Annex 120D Receiver Jitter Tolerance Test Pattern

Jan 30, 2017

Steve Sekel
Keysight Technologies

Problem with suggested test method

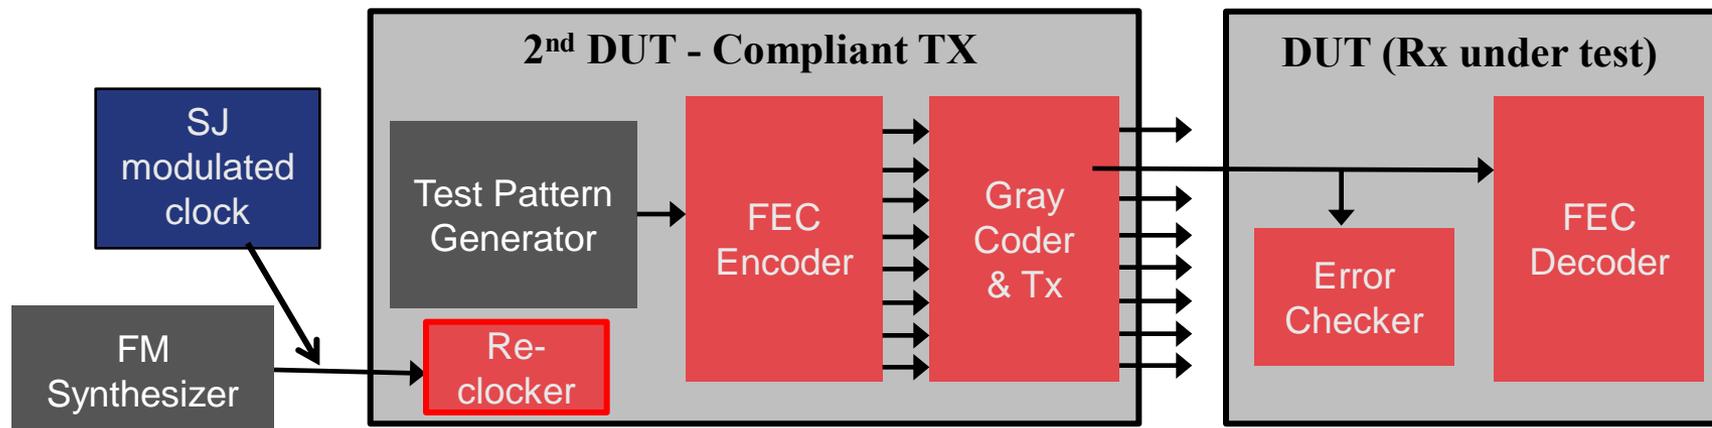
Lane 1 being tested – others driven by aggressors

- Prescribed test setup is marginal for pass/fail compliance test, but cannot test margin in most cases
- Reclocker in compliant Tx PLL often similar to CDR design in DUT Rx
 - Jitter transfer functions lie on top of each other – compliant Tx can not push enough stress to drive DUT Rx to fail
- Chip designers would like to use a BERT for margin testing
 - BUT the scrambled idle pattern is too long
 - Changing to a shorter test pattern that fits in memory or HW generated would allow use of BERT

- Receiver Jitter tolerance test can use the same test method as the interference test, but substitute **PRBS31Q** with no FEC in place of scrambled idle for the test pattern
 - The QPRBS and PRBS patterns are generated in hardware in most BERTs
 - Allows compliant pass/fail and margin testing for characterization with simplified stress calibration
- Consider using same PRBS31Q for Interference Tolerance Test (120D.3.2.1) to use common on chip error checker hardware
